RE: ^{*Subdivision*} ~~Site Plan Review:~~ ~~35 Barclay Avenue~~ *Castine Avenue*
SIX ~~Three (3) Lots Subdivision~~
Application # ~~2007-0018; CBL 339 D009001~~

I am writing to follow up on the Planning Board Workshop held on April 10th, 2007 and clarify the current status of the Subdivision Review and issues that need to be addressed prior to the project being considered at a Planning Board Hearing.

Subject: Subdivision Plan Submission
Castine Avenue, Portland, Maine

Drawing No.: **4**

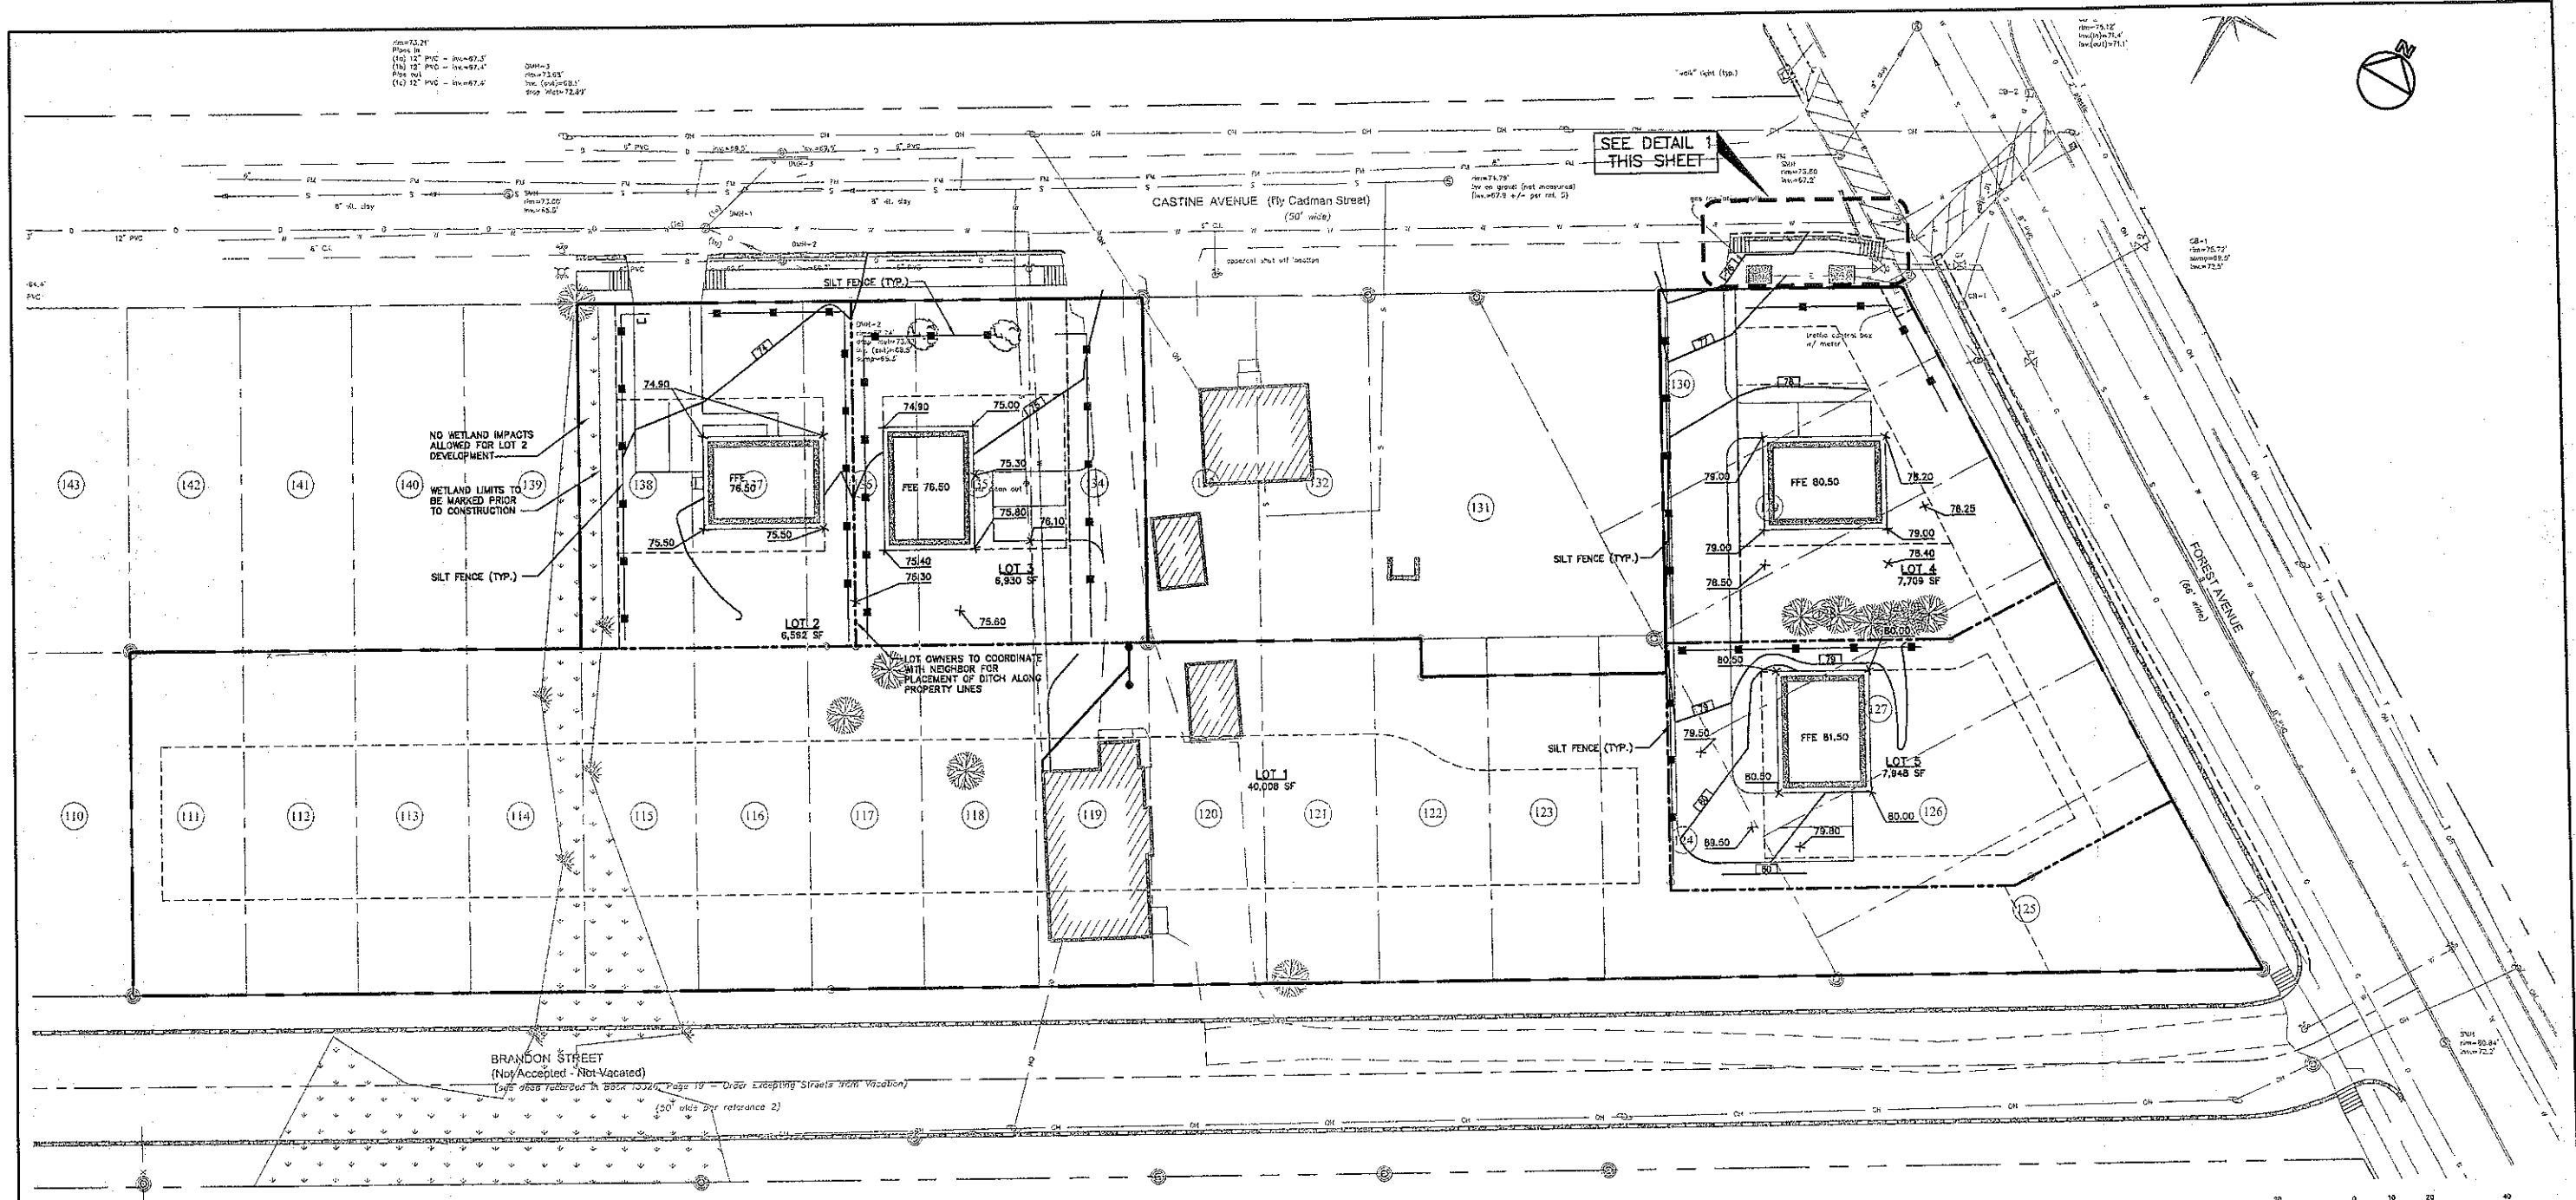
2. Mike Farmer had the following comments pertaining to Sheet 4 of the revised plans:

- *There seem to be some errors on sheet 4 with respect to the proposed sewer elevations on Lots 4 and 5. For example, on lot 5, the sewer elevation is at or above the proposed finished grade elevation near the house.*
- *On lot 2, is it possible to run the sewer lateral out the front of the house to the sewer main, eliminating the pipe elbows and the outside cleanout shown on sheet 4? With gravity sewer systems, straight pipes are generally preferred to pipes one with angles.*
- *I recommend eliminating the proposed outside sewer cleanout on lot 4. I recommend connecting the common sewer for lots 4 and 5 directly to the manhole on the sewer main in the street.*

Please revise sheet 4 to reflect the above comments prior to the Public Hearing.

2. There seem to be some errors on sheet 4 with respect to the proposed sewer elevations on Lots 4 and 5. For example, on lot 5, the sewer elevation is at or above the proposed finished grade elevation near the house.

3. On lot 2, is it possible to run the sewer lateral out the front of the house to the sewer main, eliminating the pipe elbows and the outside cleanout shown on sheet 4? With gravity sewer systems, straight pipes are generally preferred to pipes one with angles.

The sewer inverts on sheet 4 have been revised. The sewer location on lot 2 has been revised. The sewer cleanout has been deleted for lots 4 and 5 and the sewer now connects to the manhole in the street.

Response 2 – The sewer inverts on Sheet 4 have been revised. The sewer location on lot 2 has been revised. The sewer cleanout has been deleted and the sewer connects to the manhole in the street. Revised plans are included with this letter.

Drawing No.
5

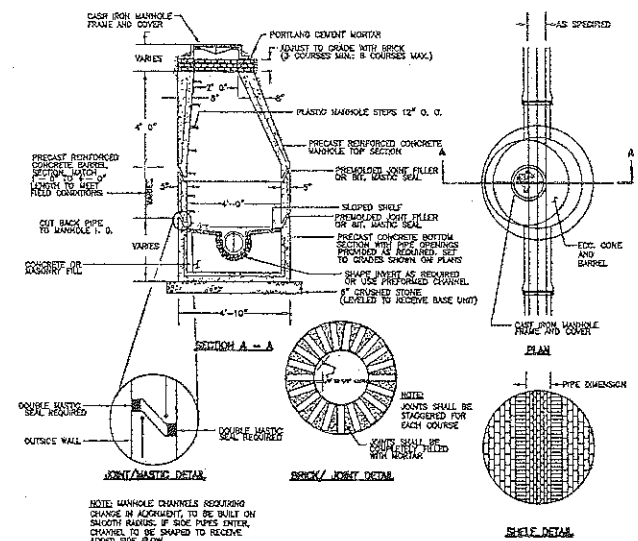
4. Please include a note on sheet 5 of the final plans clarifying that no disturbance of wetlands may occur within the 10' wide drainage easement through lot 2.
5. Please submit a draft restrictive covenant for the permanent vegetated buffers as identified on the plans for review. This, along with all easements identified on the plans, shall be reviewed and approved by the City prior to approval of the recording plat.

Comment 4 - *Please include a note on sheet 5 of the final plans clarifying that no disturbance of wetlands may occur within the 10' wide drainage easement through lot 2.*

Response 4 – A note has been added to Sheet 5 prohibiting disturbance of the wetland.
